Access Compliance Report

Public Rights-of-Way

Intersection ID: 21887	Main Street: AUTUMN_BLAZE_DR	Cross Street: WITHERS_MILL_DR	Location: E
ADA ID: CB885AB6D8FF	Ramp Type: PerpDiag	Initial Pass/Fail: Fail	Overall Compliance: No
Severity Score: 25			
Codes/Mitigation Info/Possible Solution		Field Measurements/Component Compliance

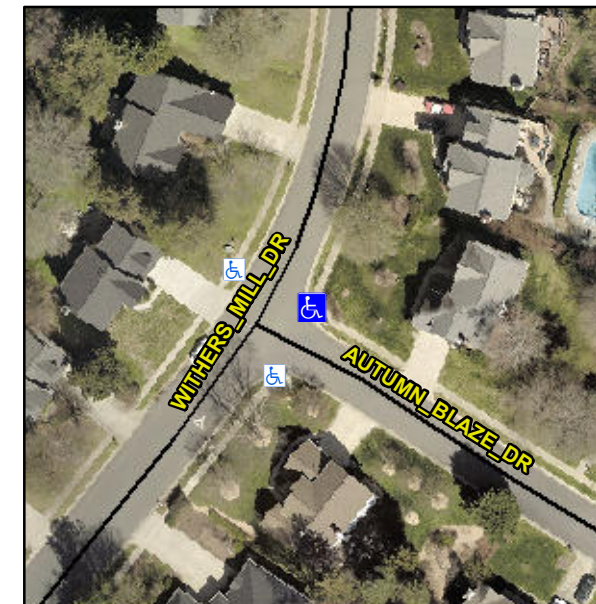
R304.5.3

Compliance	Description	Data	Compliance	Description	Data
N/A	Ramp Length (in)	94.0	Yes	Ramp Slope (%)	6.2
Yes	Ramp Width (in)	136.0	No	Ramp XSlope (%)	7.7
N/A	Flare Type LT	N/A	N/A	Flare Type RT	N/A
N/A	Flare Slope LT (%)	N/A	N/A	Flare Slope RT (%)	N/A
N/A	Flare Traversable LT?	N/A	N/A	Flare Traversable RT?	N/A
N/A	Landing Length (in)	N/A	N/A	DWS Provided?	N/A
N/A	Landing Width (in)	N/A	N/A	DWS Contrast?	N/A
N/A	Landing Slope (%)	N/A	N/A	DWS Length (in)	N/A
N/A	Landing X Slope (%)	N/A	N/A	DWS Full Width?	N/A
N/A	Landing Curb? (Y/N)	N/A	N/A	DWS Offset (in)	N/A
N/A	Shared Landing?	N/A			
N/A	Gutter Ponding?	N/A	N/A	Gutter Slope (%)	N/A
N/A	Gutter Lip Ht (in)	N/A	N/A	Gutter X Slope (%)	N/A
N/A	Painted X Walk1?	No	N/A	Painted X Walk2?	No
	X Walk 1 Direction	To NW		X Walk 2 Direction	To SW
N/A	X Walk 1 Width (in)	N/A	N/A	X Walk 2 Width (in)	N/A
	X Walk 1 Slope (%)	4.7		X Walk 2 Slope (%)	0.8
	X Walk 1 X Slope (%)	3.6		X Walk 2 X Slope (%)	5.6

Remove & Replace Curb Ramp With Two New Directional Ramps or Equivalent.
